Nº 43590

PRODUCT: DW

MODIFICATION AT THE ALTERNATIVE MOTOR DRIVE

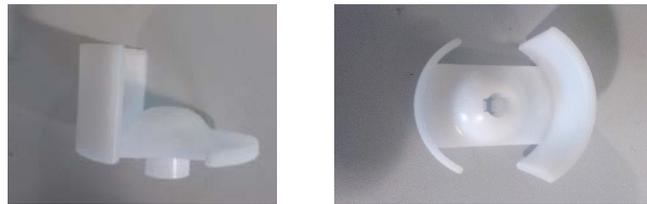
The customer is claiming about a noise and in most of the cases it is not giving any fault code. This noise may not appear in the beginning of the washing program but once the program is in execution

Mainly, the problem occurs due to a design error in the plastic part attached to the motor drive (diaphragm) used to alternate the washing between the top and the bottom of the washing machine. Photos of the Diaphragm:

Remove of the plastic part (diaphragm). The lack of the diaphragm doesn't make any leak in the dishwasher. The spare part (AS0014710) will be supplied as shown in the picture below.

To change the motor drive.
